McKinney Independent School District, TX
Procurement
Laura Duree, Director of Purchasing
1 Duvall St, Mckinney, TX 75069
(972) 542-7410

QUESTION & ANSWER REPORT

RFP No. 2026-10-652

E-RATE CATEGORY 2

MCKINNEY BOYD HIGH SCHOOL FLOOR 1:

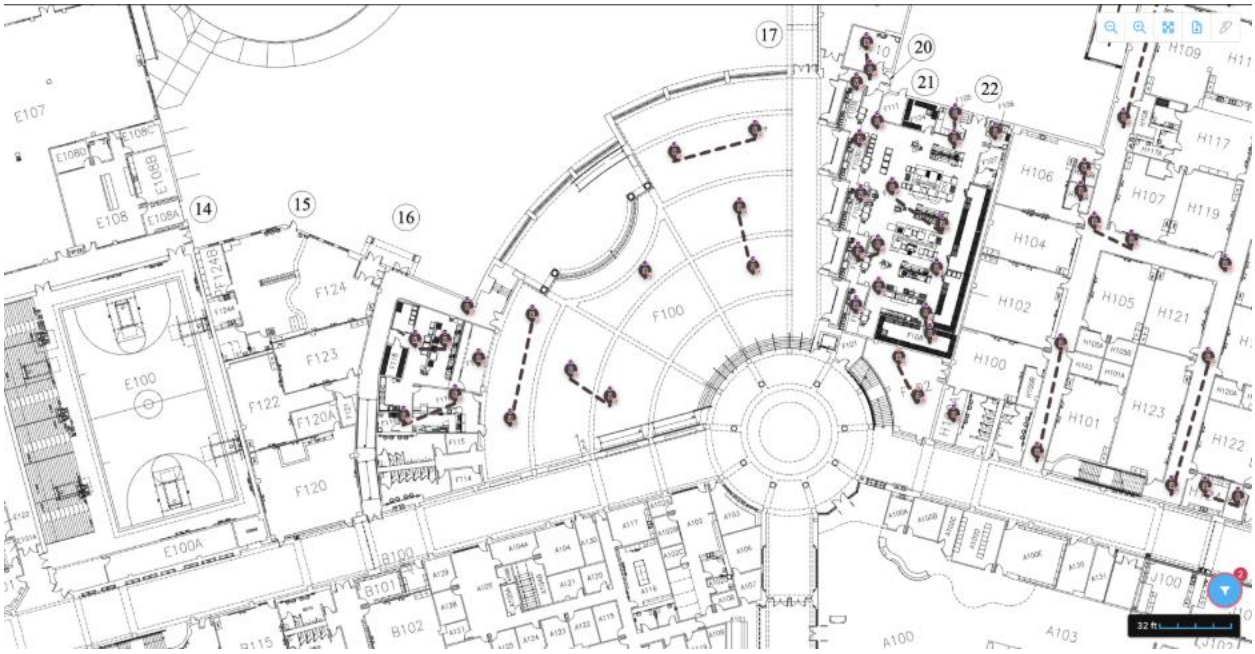
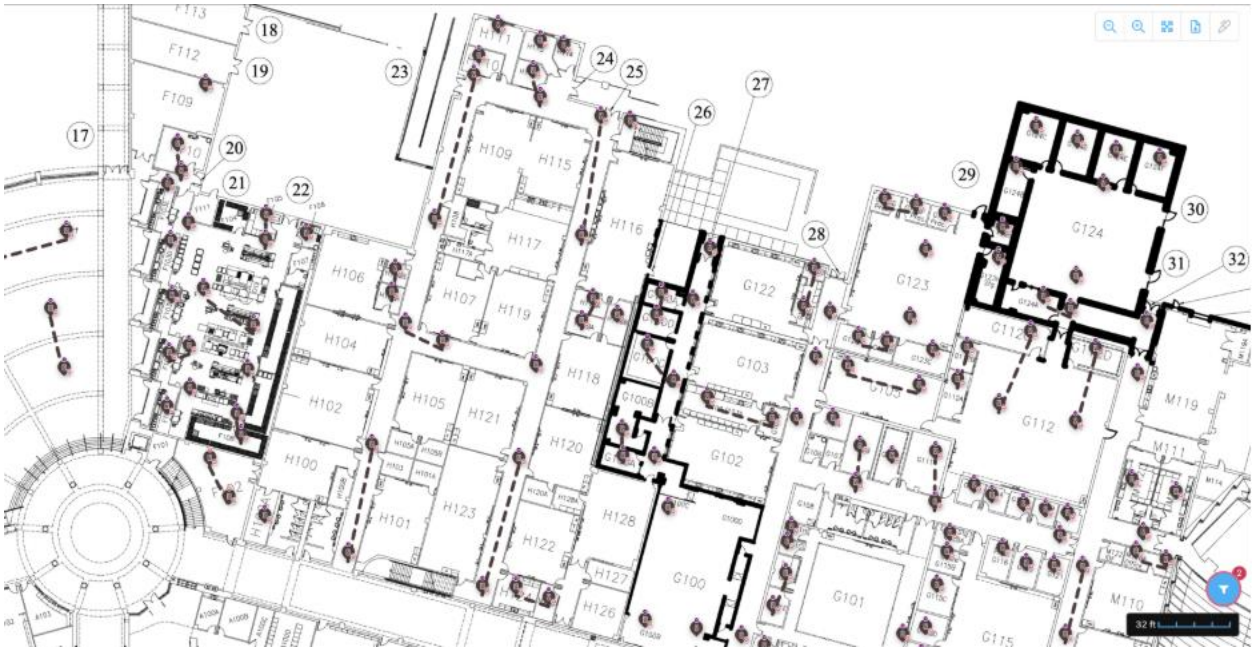
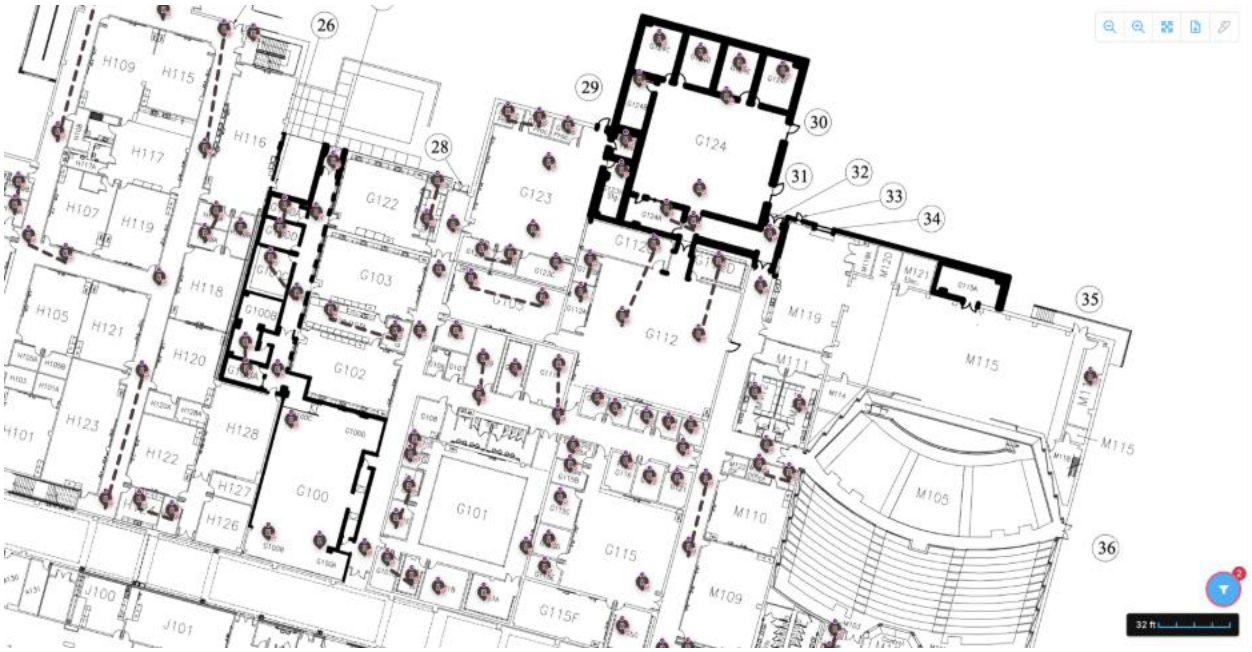
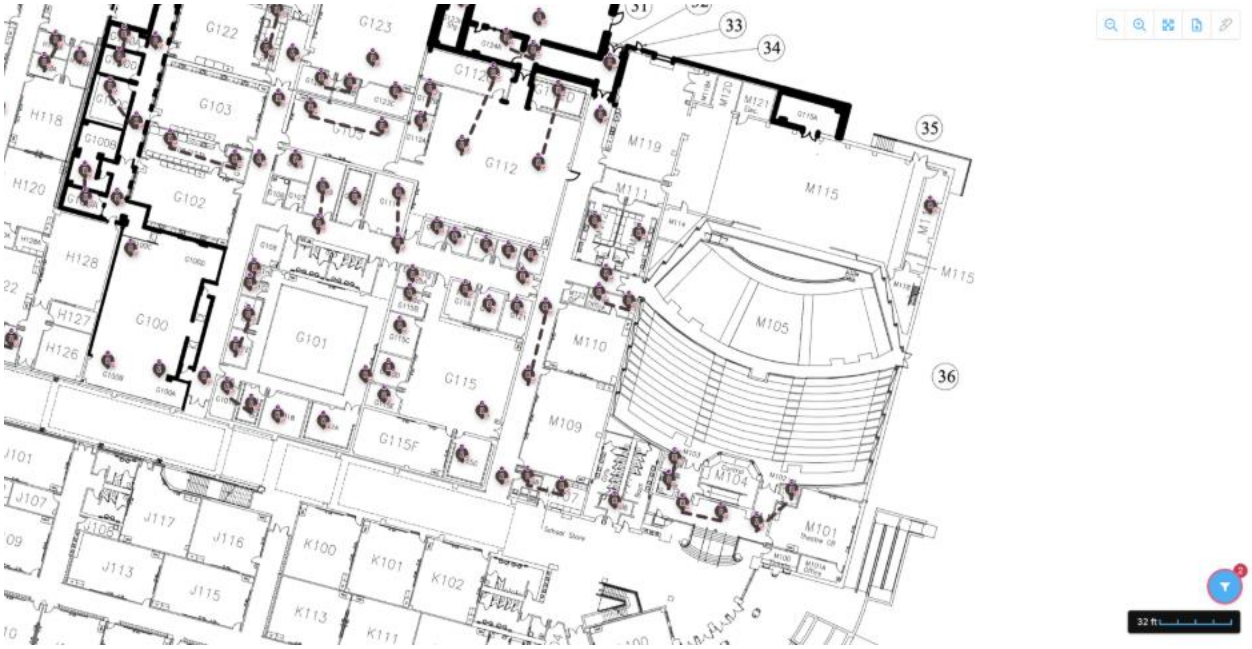
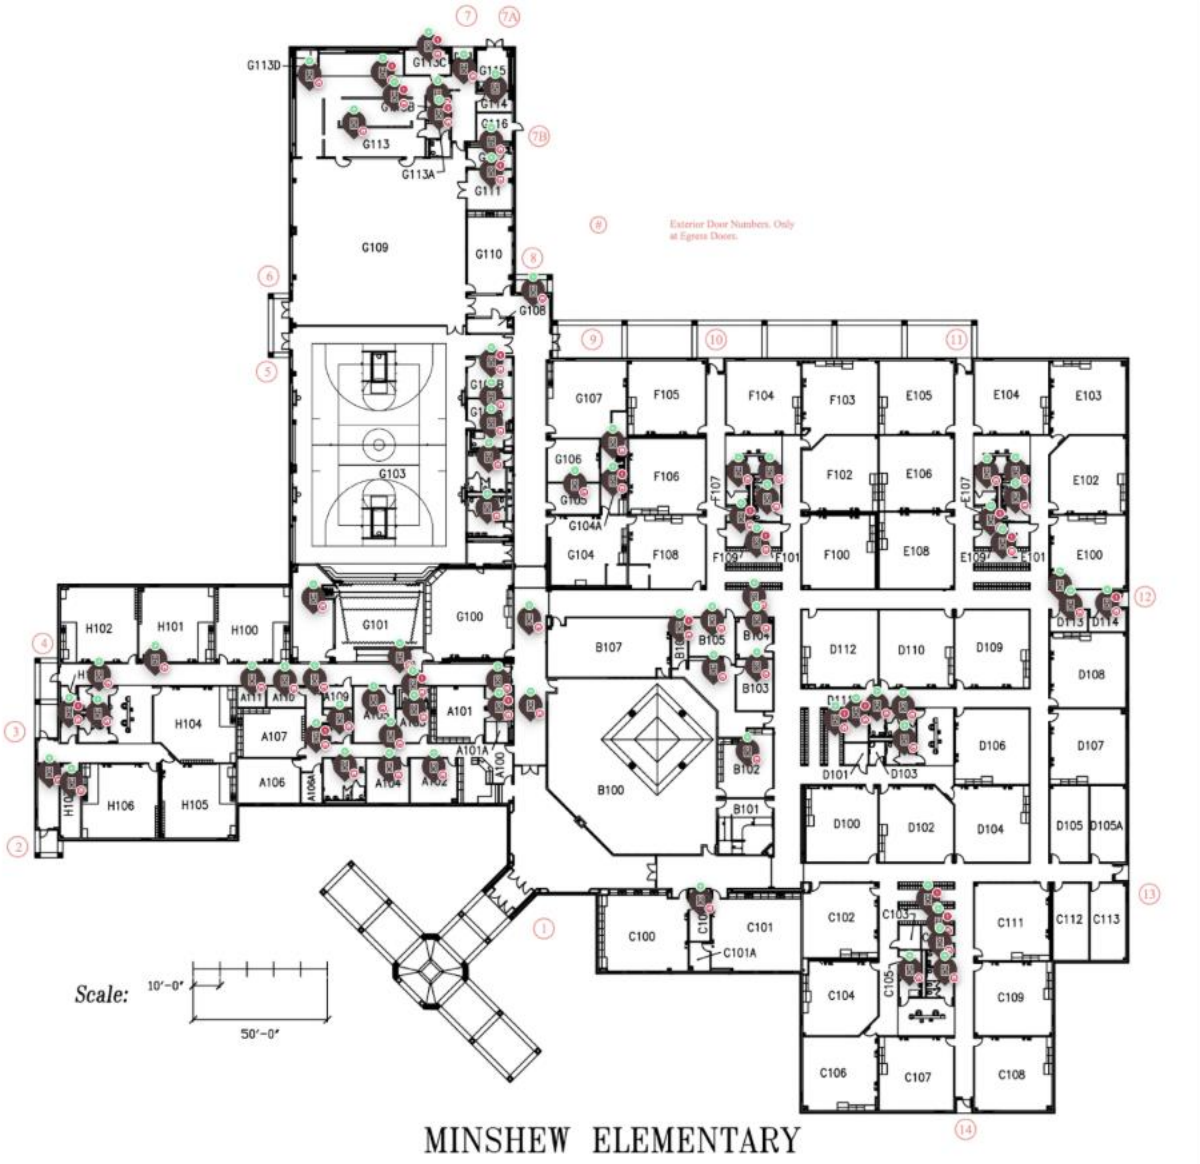
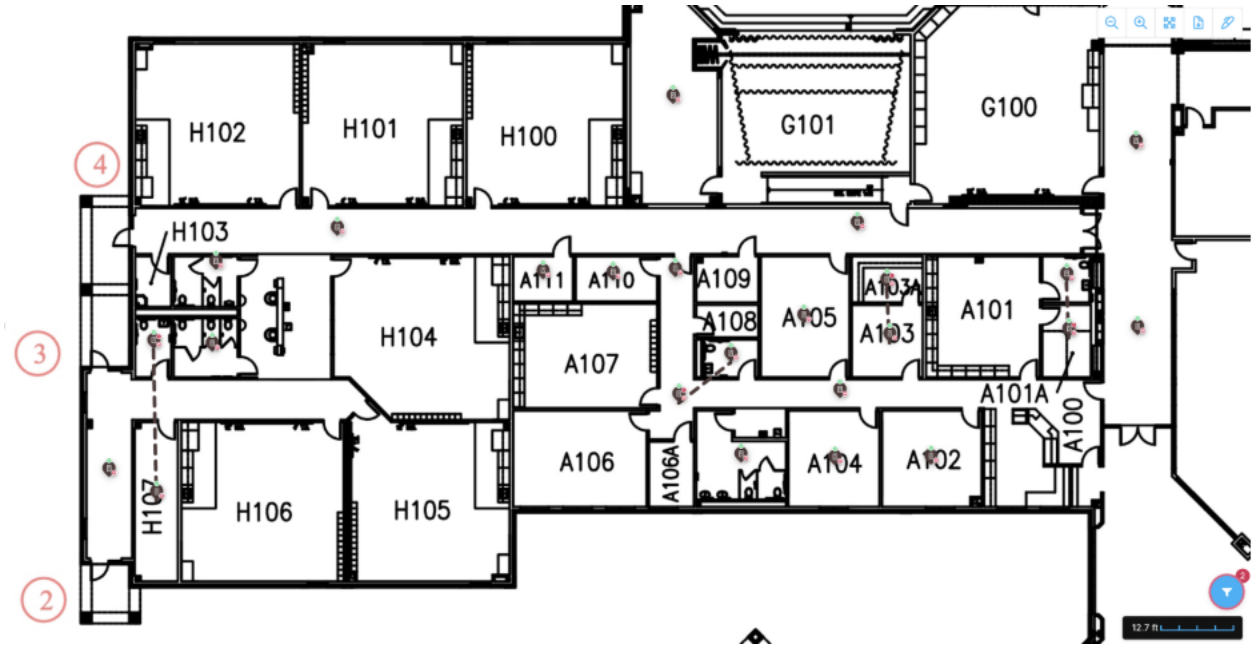
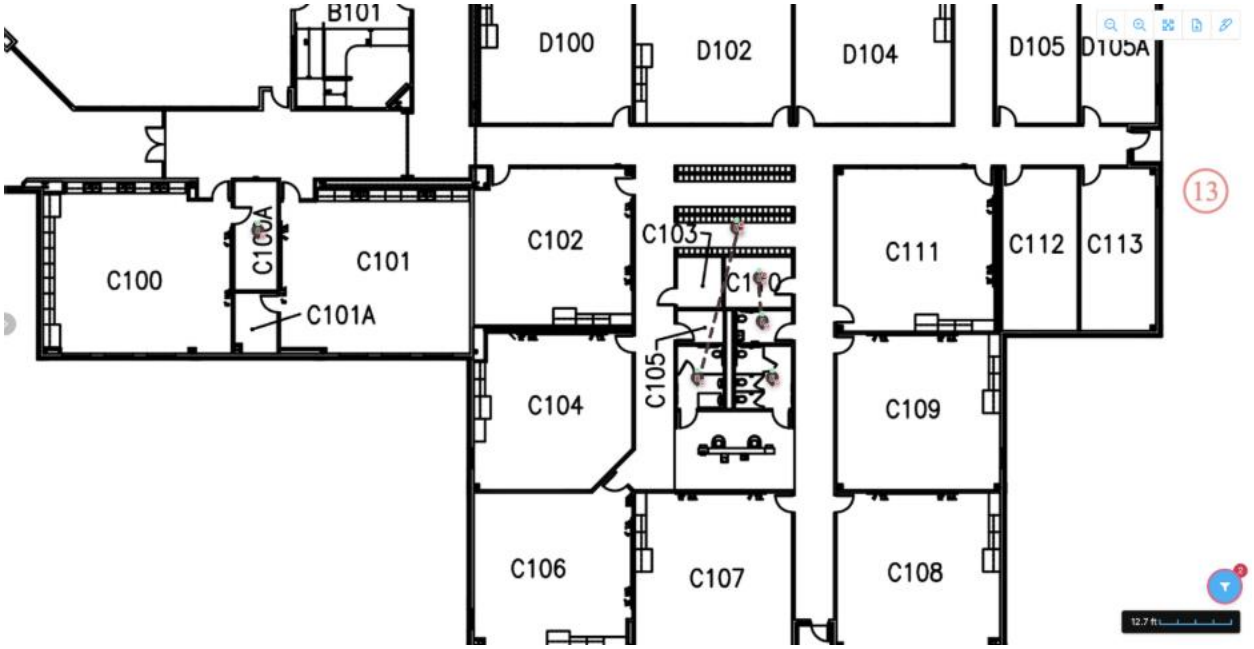
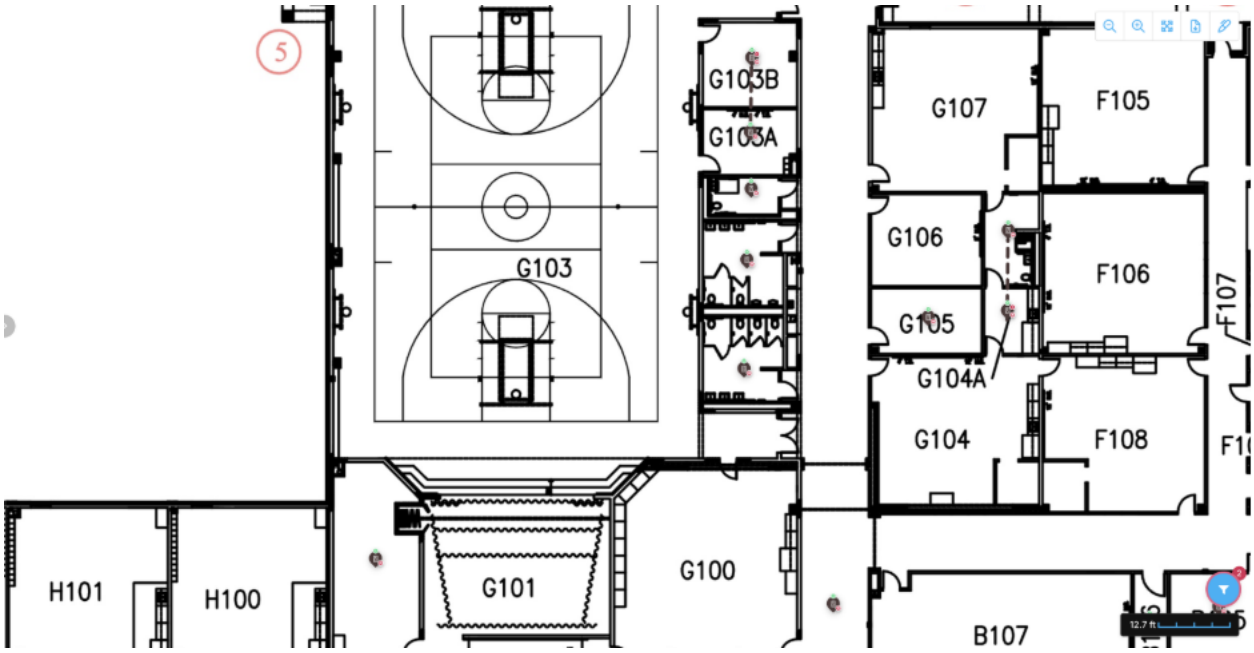
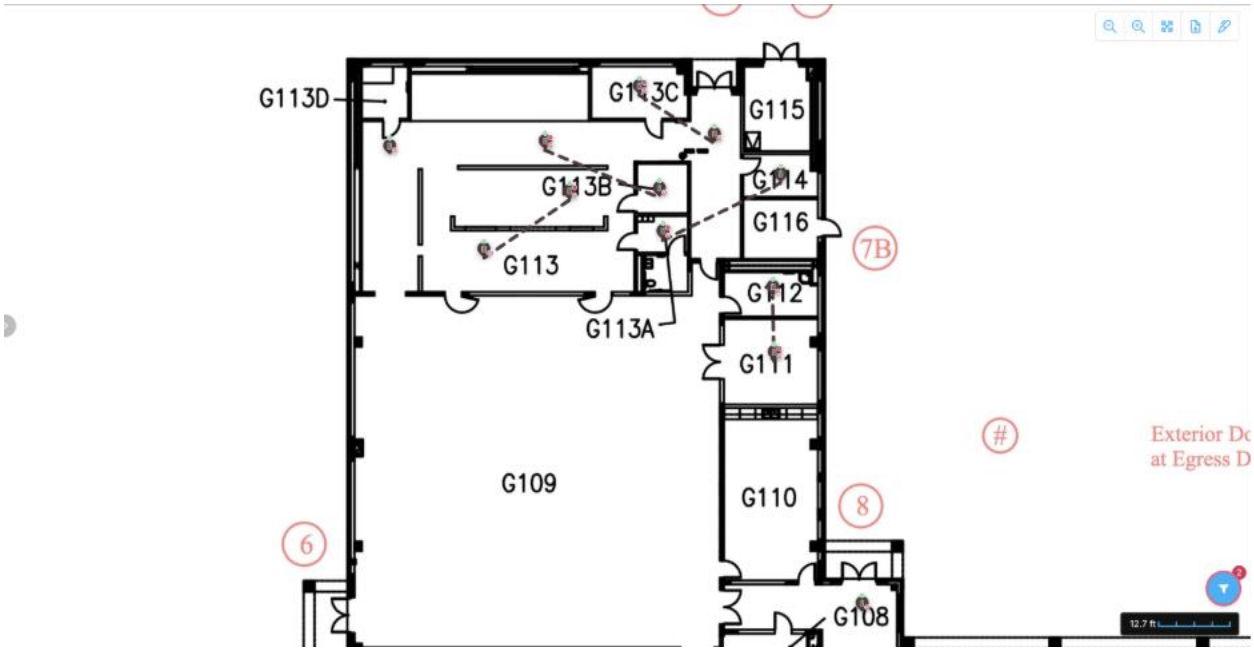
Question: Where are the speakers drops and extension speakers going?

Answered by Laura Duree: The speaker & extension speaker locations will be provided in an addendum.

MCKINNEY BOYD HIGH SCHOOL FLOOR 1

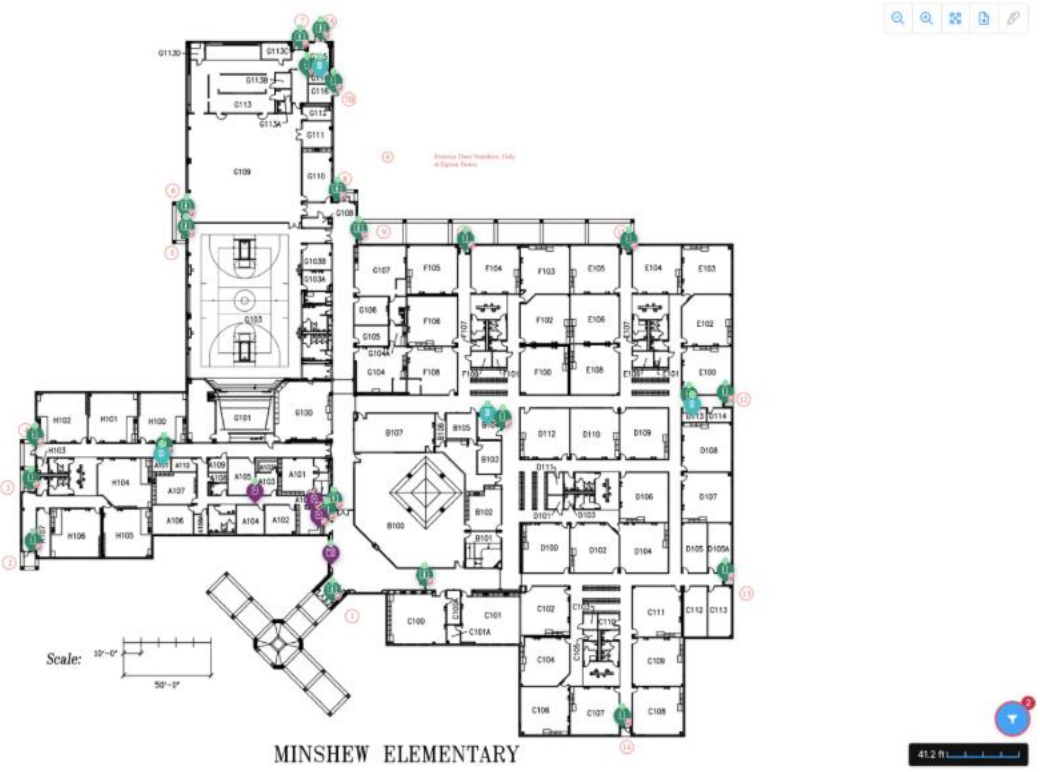
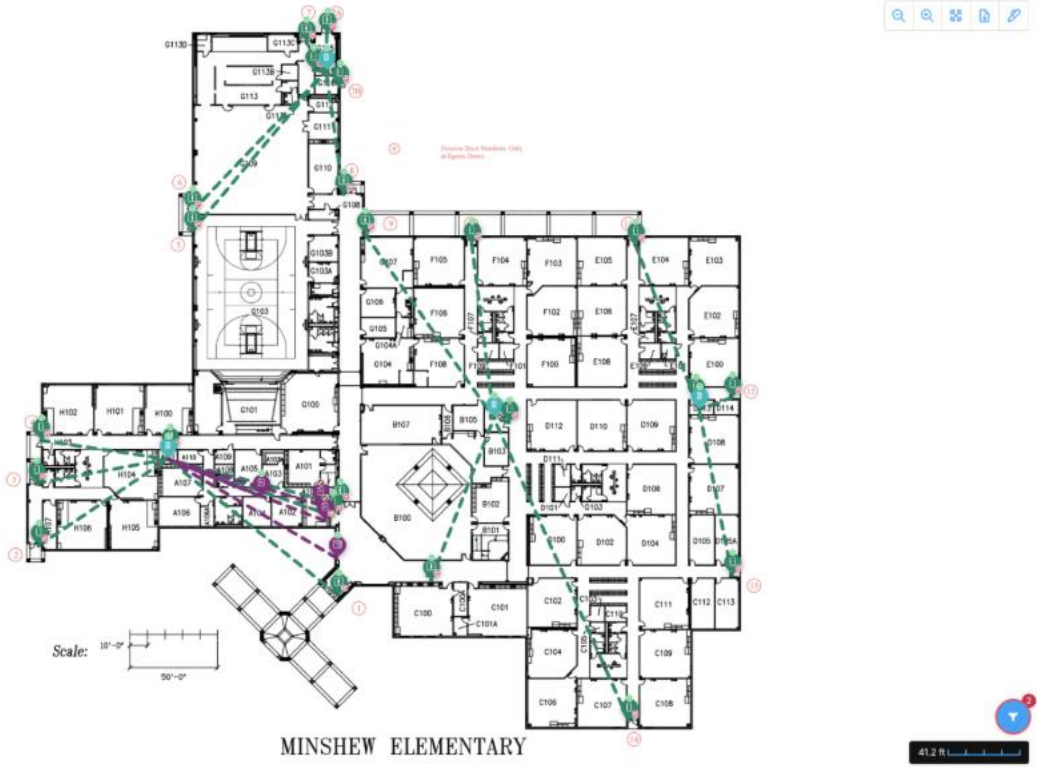
Question: The speaker cables are the only non-ethernet cables being installed?

Answered by Stephen McGilvray: No, the access-controlled doors will need composite cables. There are other doors that are DPI sensor only that will not need the full composite cable but will need the 18/4 cable. The door locations will be provided in an addendum.
